Sindh Barrages Improvement Project

Rehabilitation of Guddu Barrage – Addendum to
Abbreviated Resettlement Plan (ARAP)

January 2021

Figure 3.1: Amendments to Works at Guddu Barrage

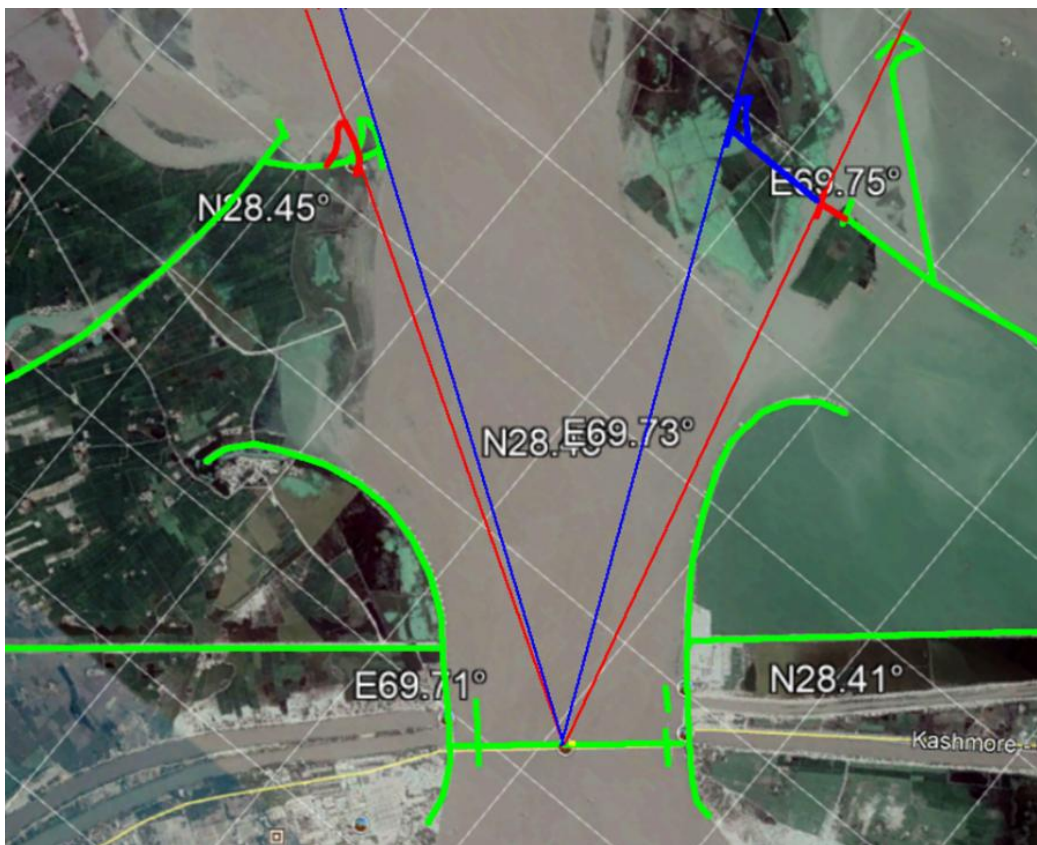
The works under the sub-project are as described in Chapter 3, with the following amendments:

- Reduction in the proposed length of the T-spur on the left bank, and realignment of the spur head; and,
- Reduction in the existing length of the existing J-spur on the right bank, and realignment of the spur head.

Green: existing spurs and banks

Red: proposed works to spur

Blue: Previously proposed extension to left spur which has now been removed from scope of works.
